# CITY OF ALBUQUERQUE

**RE: Dunkin Coffee Shop  
1600 Eubank Blvd. NE  
Grading and Drainage Plan  
Engineer's Stamp Date: 09/25/2024  
Hydrology File: J21D004A**

**GRADING PLAN**

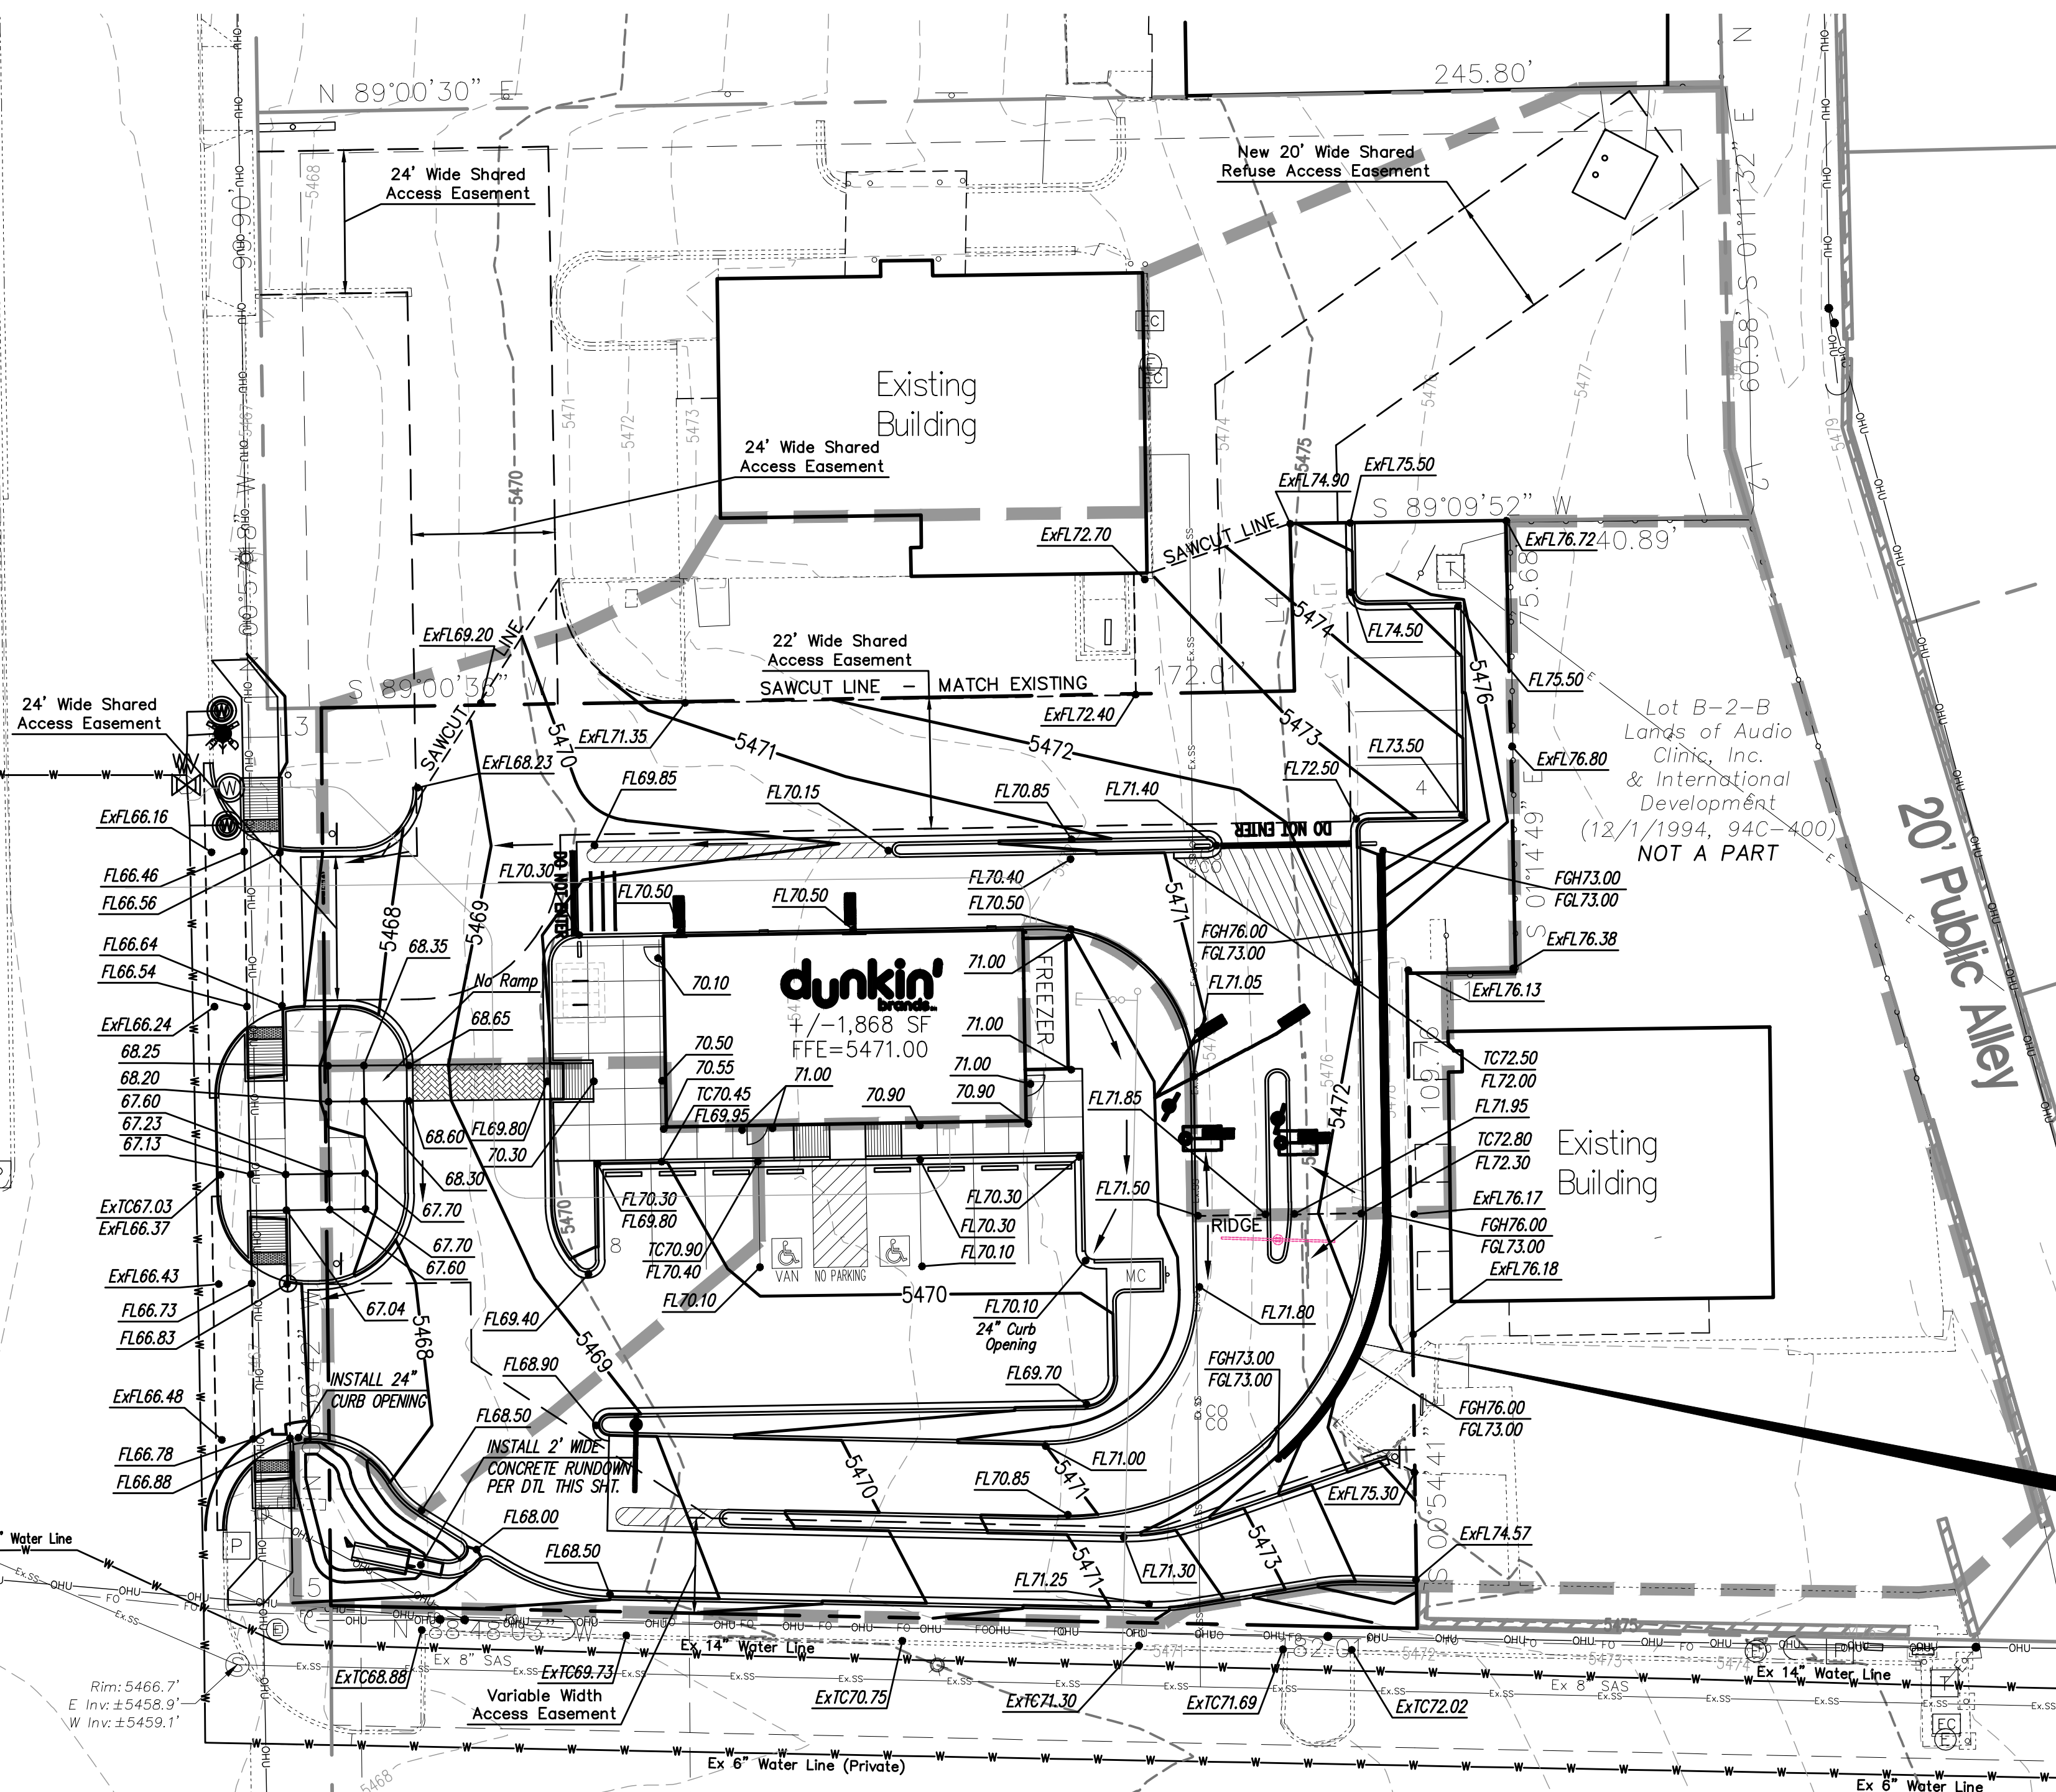
Based upon the information provided in your submittal received 09/25/2024, the Grading and Drainage Plans are approved for Building Permit and Grading Permit. Please attach a copy of this approved plan in the construction sets for Building Permit processing along with a copy of this letter.

1. Engineer's Certification, per the DPM Part 6-14 (F): *Engineer's Certification Checklist For Non-Subdivision* is required.
2. Please pay the Payment-in-Lieu of \$ **2,376.00** by emailing the attached approved Waiver Application from Stormwater Quality Volume Management On-site to [PLNDRS@cabq.gov](mailto:PLNDRS@cabq.gov). Once this is received, a receipt will then be produced and email back. Follow the instructions on the bottom of the form and pay it at the Treasury in Plaza de Sol. Once paid, please provide proof of payment.
